FUSE BOX CONNECTIONS • INSPECT AND TORQUE TIGHTEN 9700 (B13R)

Year model : 2009 to 2011 incl.	From chassis 127142 up to 148659 incl.
---------------------------------	--

Safety Recall

SR11-52A

F106	F105	F104	F103	DIST. UNIT	STARTER	CHARGER	BATTERY	DIST. UNIT
16Nm	16Nm	31Nm	31Nm	31Nm	42Nm	31Nm	31Nm	31Nm
30+	30+	30+	30+	XC104	XC103	XC102A	XC102B	XC101
20903651

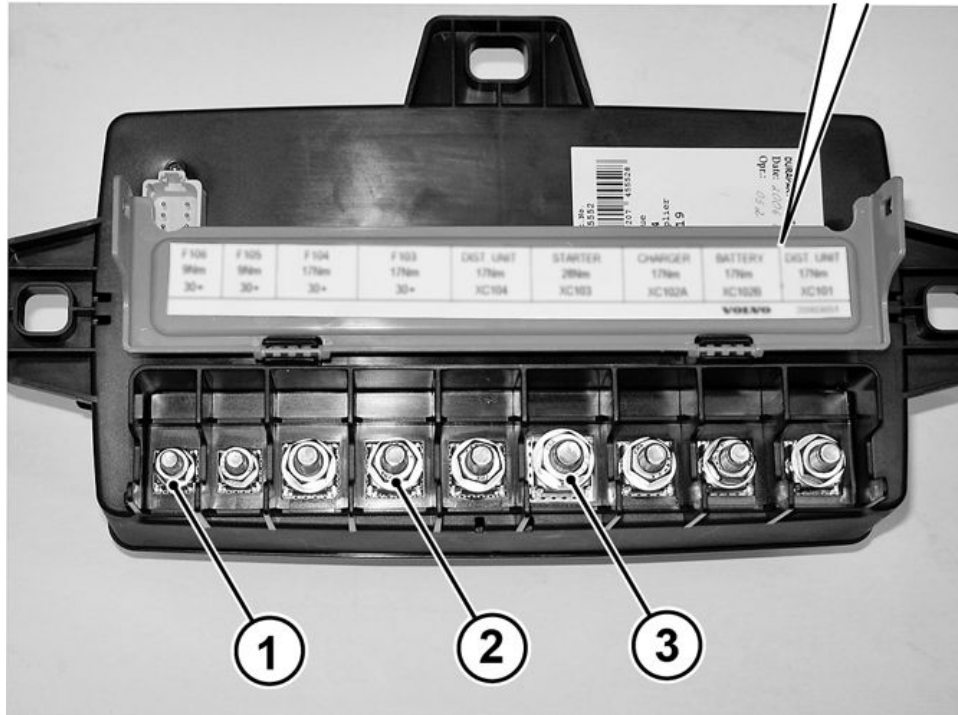
2. Check for any damages, inspect and torque tighten all cable connections on front fuse box. See method below. Check also clamping to the bracket of all connected cables and remedy when necessary.

1. M8 screw cable terminals: **16 Nm±10% (12 lb-ft±10%)**
2. M10 screw cable terminals: **31 Nm±10% (23 lb-ft±10%)**
3. M12 screw cable terminals: **42 Nm±10% (31 lb-ft±10%)**

Check for correct position of washers (B, C) and torque tighten all cable terminals. Make sure the specified tightening torques are obtained.

T1065543

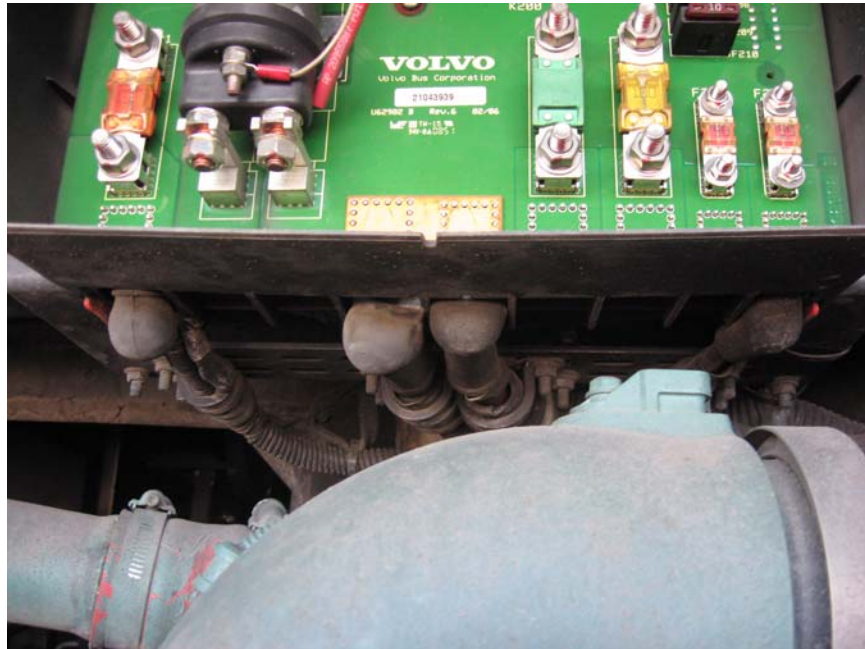
Fuse box connections, inspect and torque tighten

- A. Cable terminal
- B. Flat washer
- C. Spring washer
- D. Nut
